Important behavior change: TECDIS 4.7.x.25 – course to steer

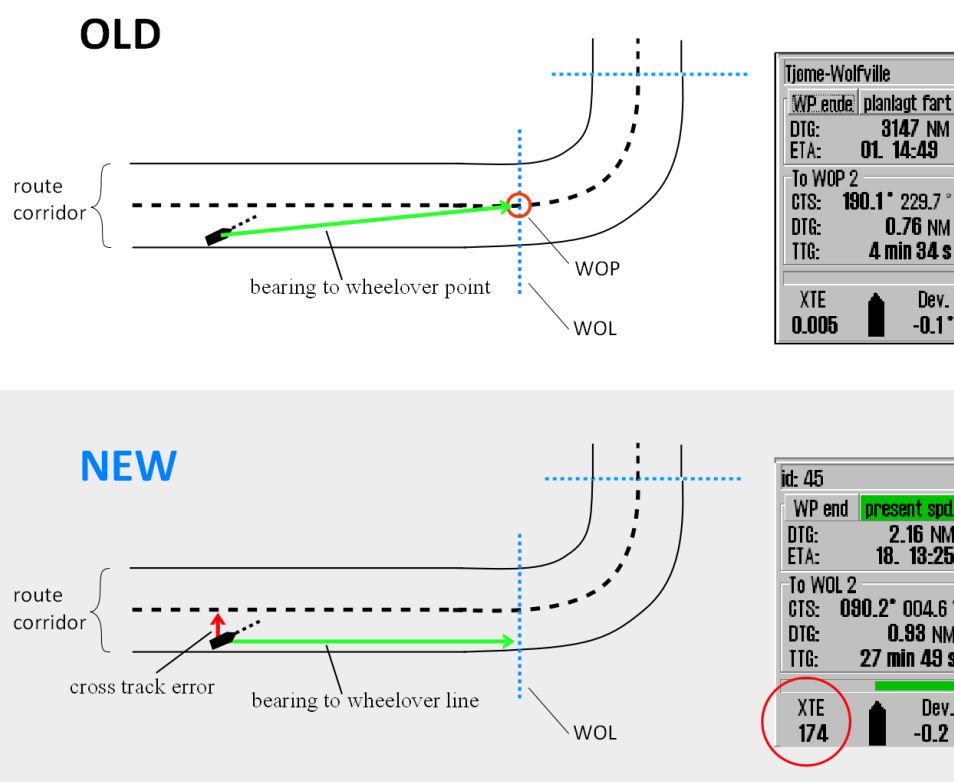
As of this version, **Course to Steer** (CTS) in the *route steering information box* is now calculated to the **Wheelover Line** (WOL). Previously, this was calculated to the wheelover point (WOP).

The following figure shows the difference from previous to current behavior:

As of this version, you should use **Cross Track Error** (XTE) and the vessel's *Course Over Ground*(COG) in relation to the CTS to correct your heading when steering towards a waypoint.
